CABO VERDE RENEWABLE ENERGY AND IMPROVED UTILITY PERFORMANCE PROJECT

CLARIFICATION #6

Contract Title: Request for Bidding - Procurement of Plant, Design, Supply, and Installation for Five (5) Energy Storage Systems in FOGO Island, SANTO ANTÃO Island, SÃO NICOLAU Island, MAIO Island and

RFB Reference No.: 016/REIUP/UGPE 2

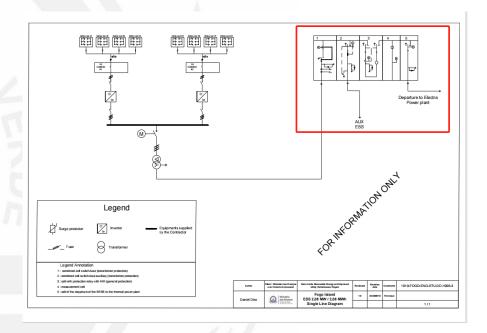
QUESTION 32: May I ask the 20kV grid connected distribution cabinet is include of the Scope of bidding, cause the drawing sheet was not very apparent.

ANSWER N°32: The bidder shall supply, install, and commission the switching cabinet to be located in the thermal Power Plant switching room or in the new substations.

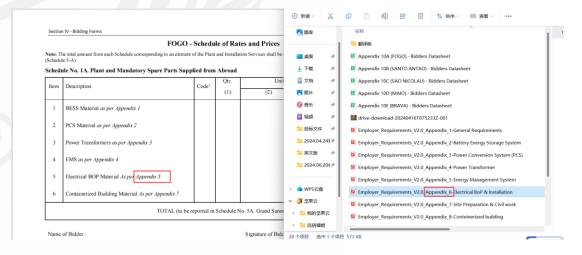
QUESTION 33: According to page 131 of the tender document, The form of the Financial Part, the list of the Price form is not match with the Downloaded attachments, for example:

ANSWER N°33: Please consider as follows:

- BESS Material as per Appendix 2
- PCS Material as per Appendix 3
- Power Transformers as per Appendix 4
- EMS as per Appendix 5
- Electrical BOP Material As per Appendix 6
- Containerized Building Material As per Appendix 8
